OSA -0599-68

Subject: LOCAL MODIFICATION TO P/N DN55000 PARACHUTE

Enclosures: Photos #18414 and #18413

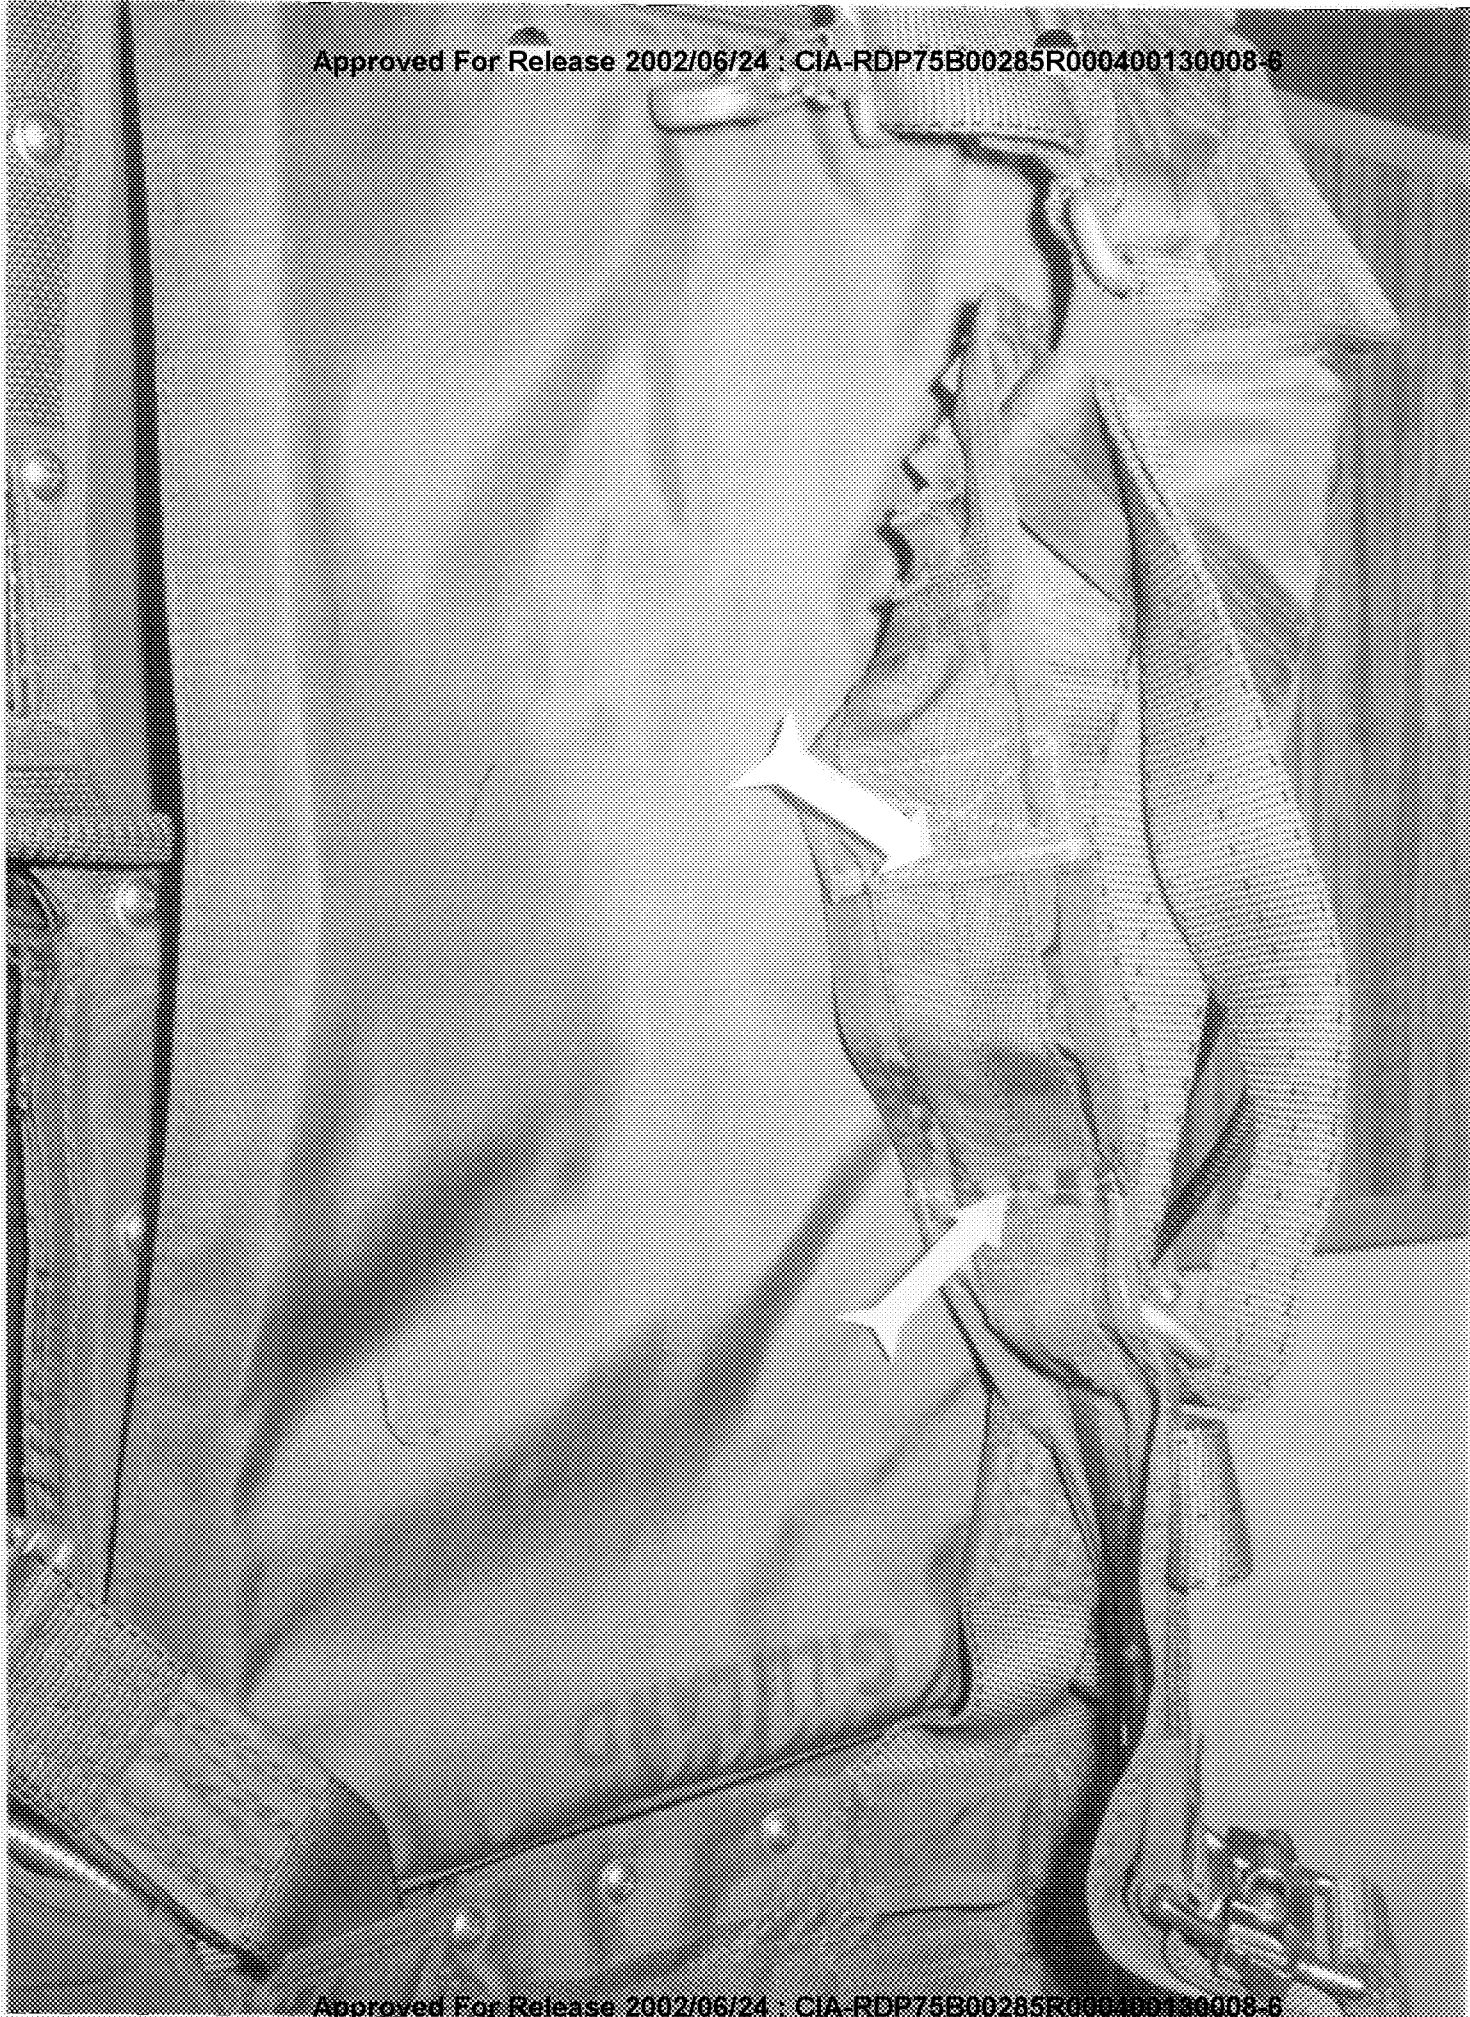
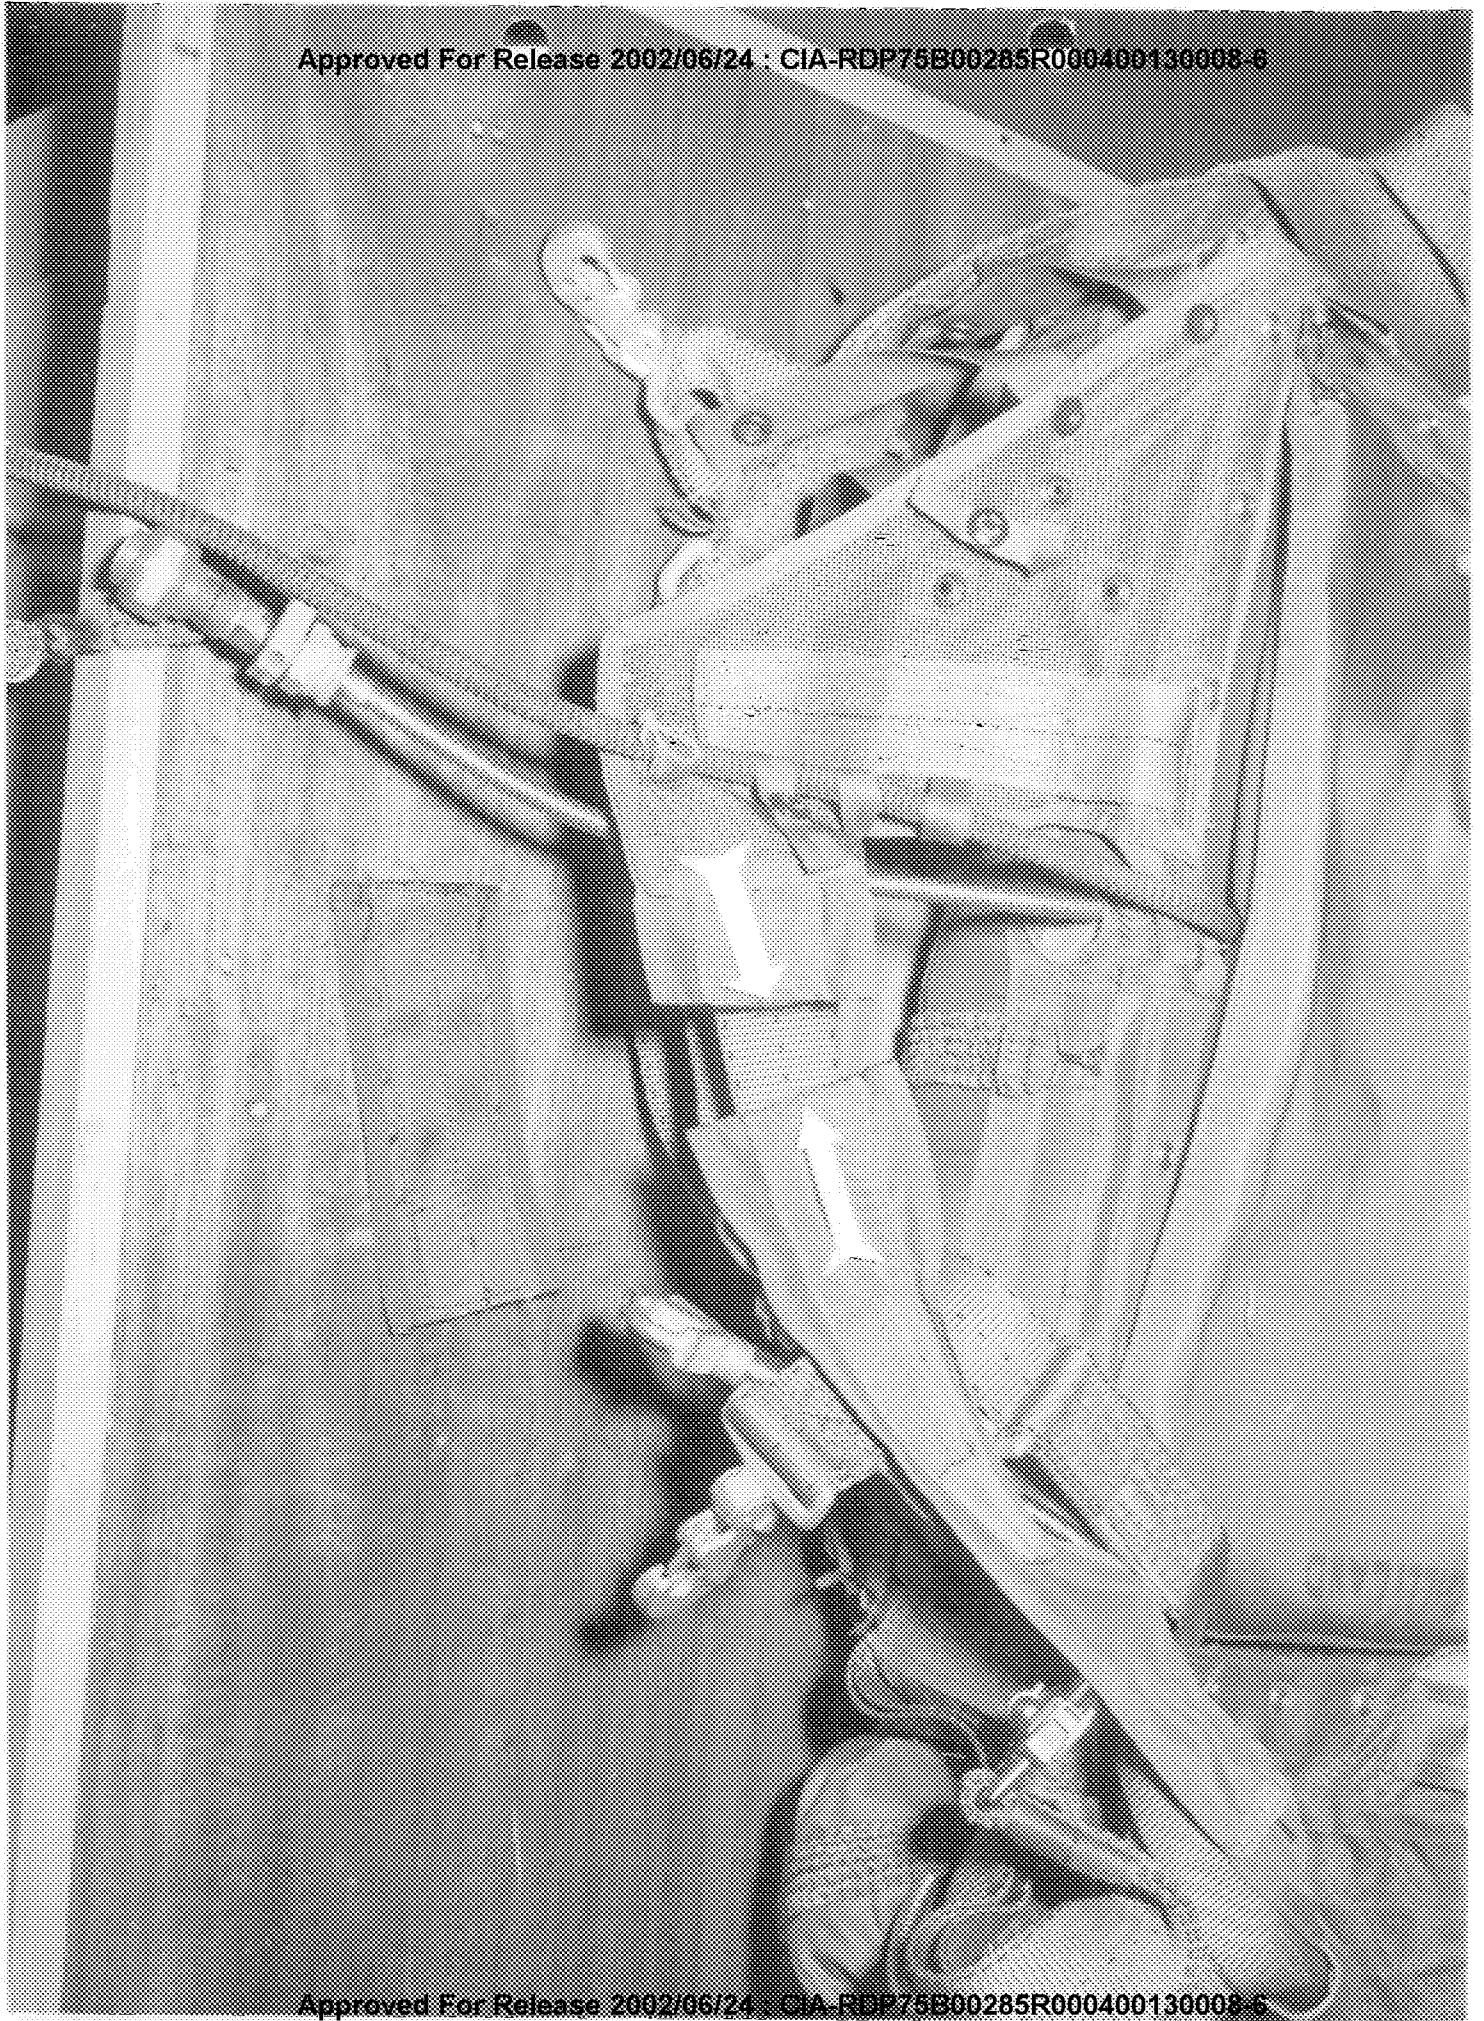
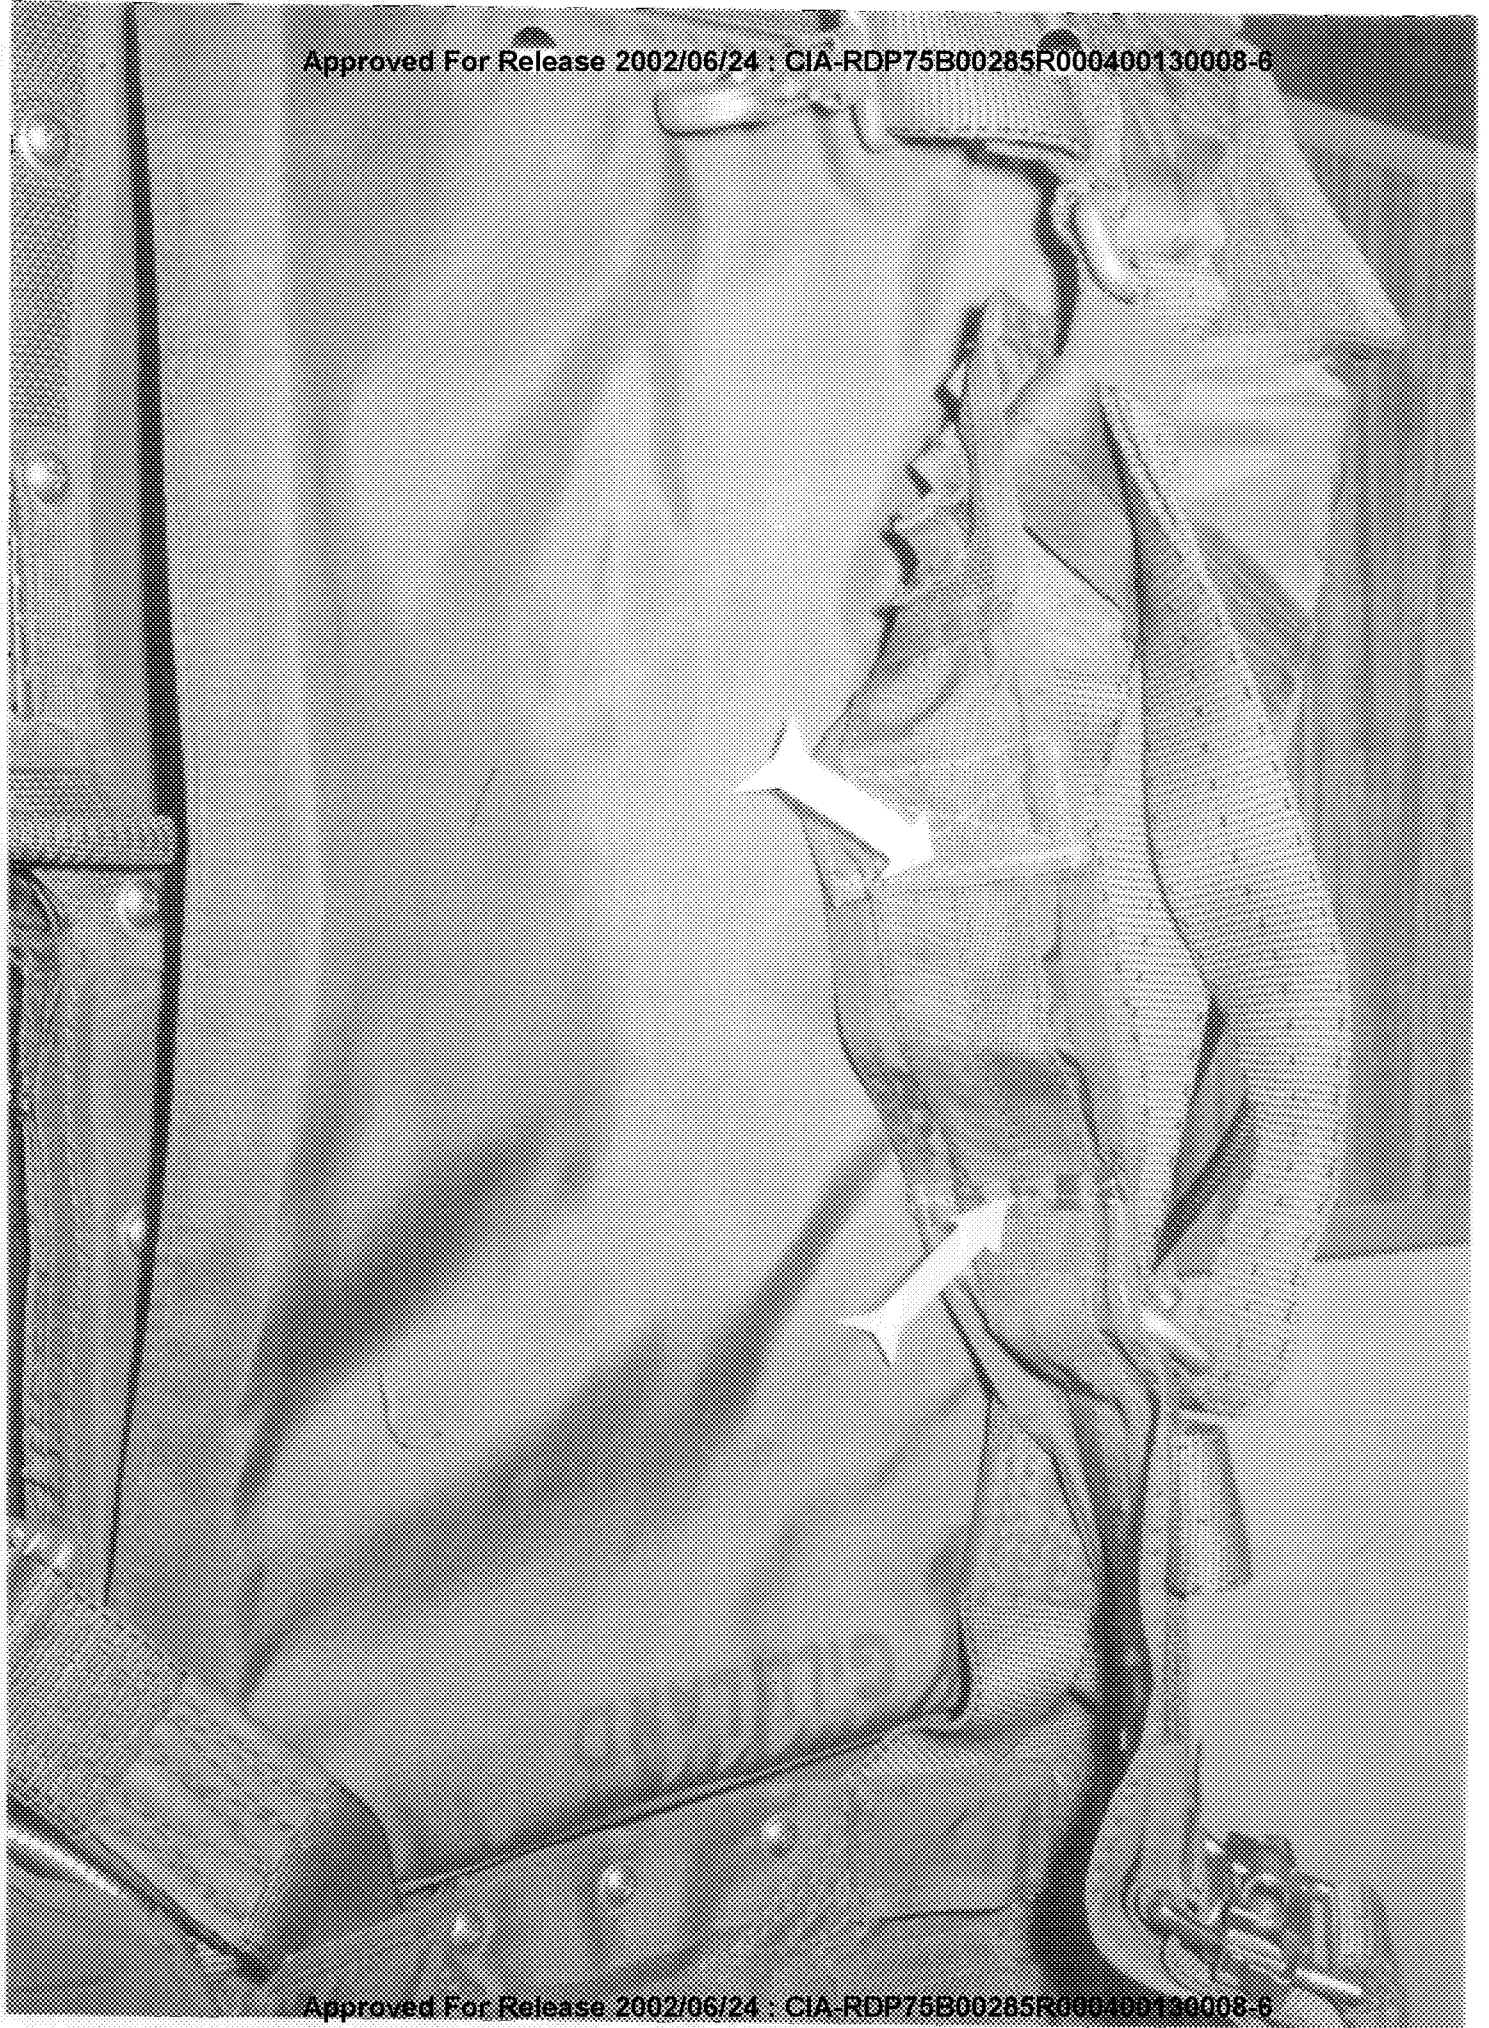
Enclosed photos show a modification incorporated to one DN55000 Parachute, by BW-4 personnel.

The modification consists of a four-inch extension to the non-structural fabric beneath the two vertical lift webs.

This modification was required in order to permit length adjustment of the lift webbing on pilot

Prior to the modification, the fabric limited the harness length adjustment and put intolerable pressure on Bob's shoulders.
